Systematic Tx Eye Mask Definition

John Petrilla,
Avago Technologies
March 2009

- Problem statement & solution
Comment Reference: P802.3ba D1.2, Comment 97
- Reference Material
 - Systematic Approach Proposition
 - Jitter Allocation
 - Extended 10GbE Link Model
 - Generating Eye Masks
 - Base Case

TP2 Eye Mask Problem

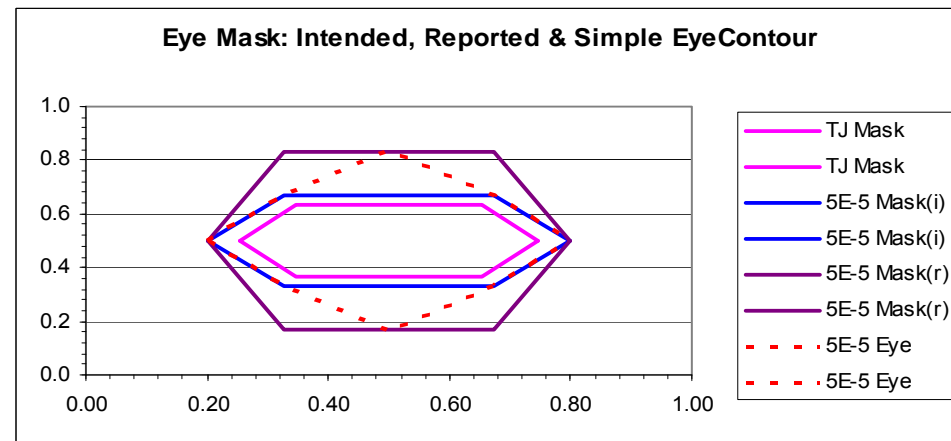
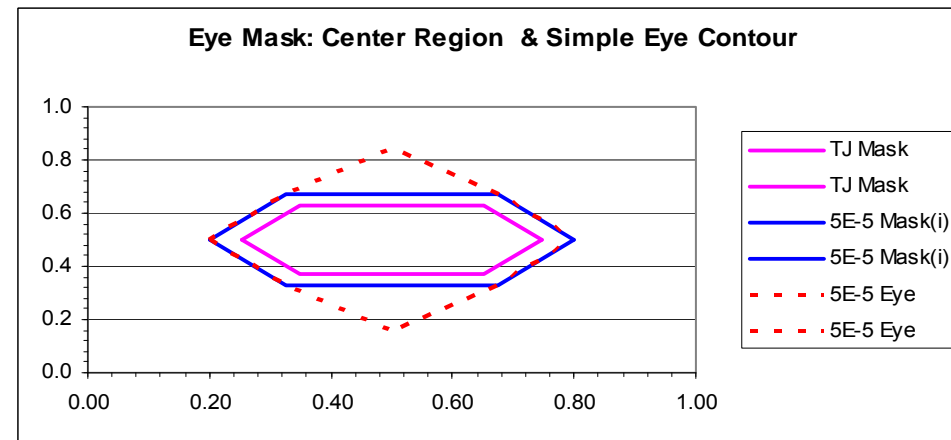
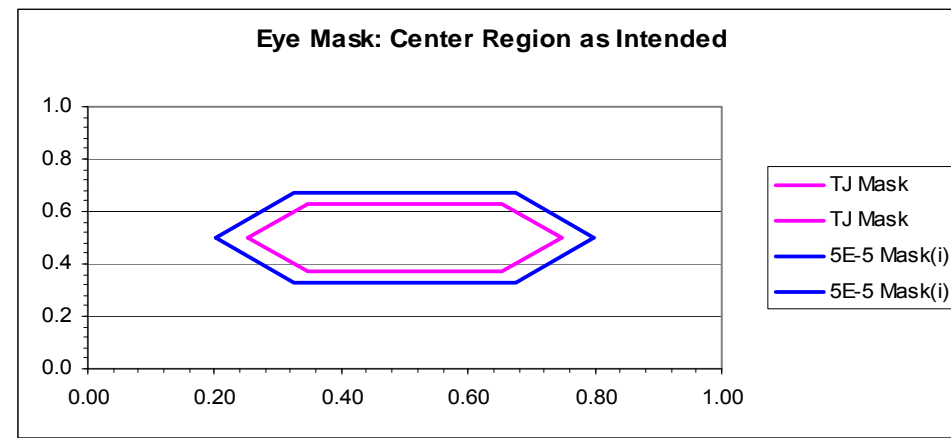
- Problem:
 - The proposal for optical Tx eye mask coordinates in Comment 427 on P802.3ba D1.1 contained an error; an intermediate value for coordinates Y1 & Y2 was reported instead of the final result. Continuing with the errant value will place an unnecessarily severe burden on an optical Tx.
 - The error in Comment 427 was noticed and reported along with the corrected value in petrilla_01_0109. Unfortunately, although the recommendations in Comment 427 were largely accepted, this correction reported/proposed in petrilla_01_0109 was not implemented.
- Solution:
 - Adopt the remedy proposed in Comment 97 on D1.2. This is consistent with the correction to Comment 427 proposed in petrilla_01_0109.
 - In Table 86-8 change Tx eye mask coordinates Y1 & Y2 from 0.17 to 0.33.

The top and middle figures on the left show the intended mask, 5E-5(i), the eye contour on which the mask is based, 5E-5 Eye, and the associated mask based on a BER = 1E-12, TJ Mask.

The bottom figure shows, in addition, the mask, 5E-5(r), using the mistaken coordinates. Since this is a normalized amplitude mask, this mask requires a significant reduction in transition time and jitter beyond that required by the link budget and worst case combination of cable plant and Rx. Increasing OMA doesn't help.
